## Engineering Change Notification

Supplier Name: Heller Industries

### Reactor Catalyst Remove Tooling

ALPHA 2043MK7NGBA ALL OVEN

RFC355

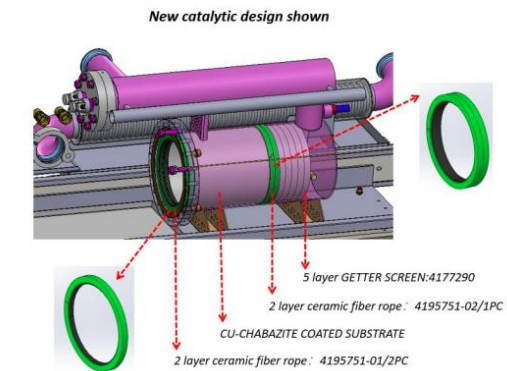
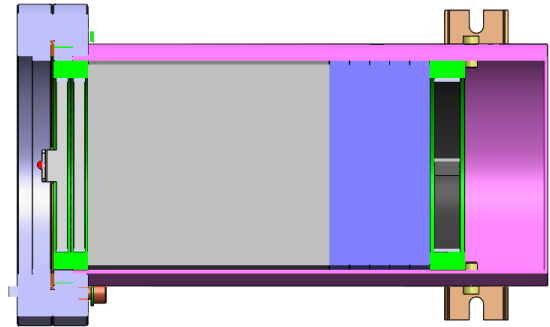
Change Ring install location

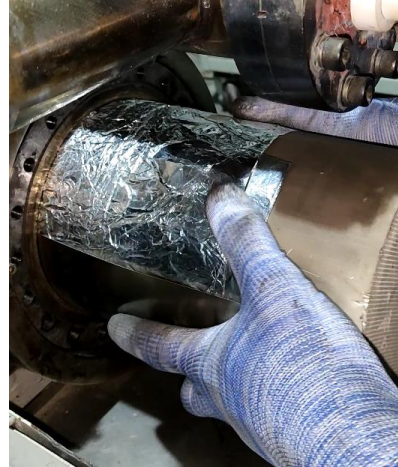
Wrap catalyst and black mesh together with aluminum foil

Install new inside ring

Put the stainless steel leather bag outside the catalyst and put it together in the REACTOR

Install new outside ring

4195751-XX

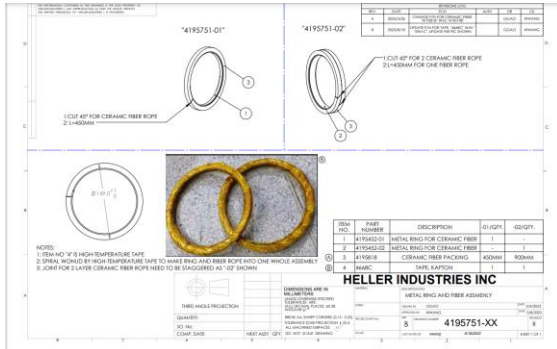
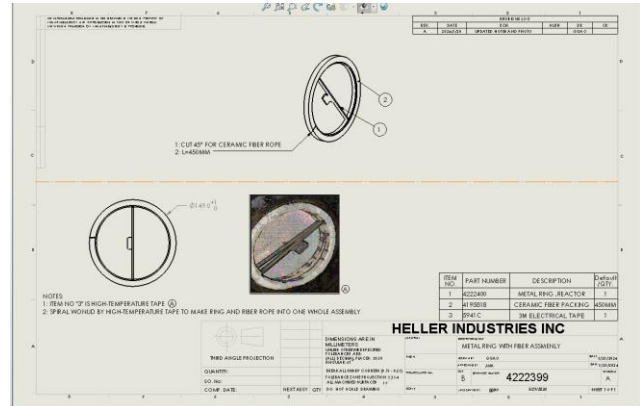
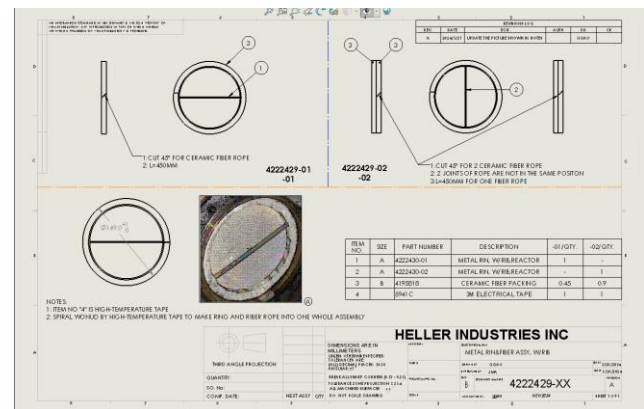
| Change Item                     | Present Value | Proposed Value     | Reason for Change          |
|---------------------------------|---------------|--------------------|----------------------------|
| METAL RING AND FIBER ASSMENLY   | 4195751-XX    | 4222429-XX+4222399 | For easily remove Ring     |

4222401

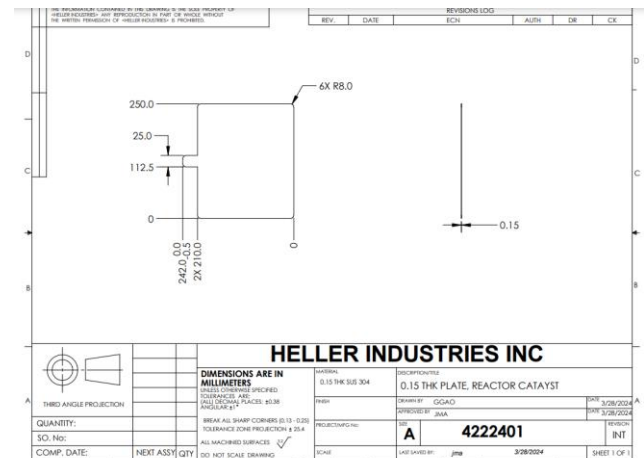
| Change Item                     | Present Value | Proposed Value     | Reason for Change          |
|---------------------------------|---------------|--------------------|----------------------------|
| 0.15 THK PLATE, REACTOR CATAYST | N/A           | 4222401            | For easily remove Catalyst |
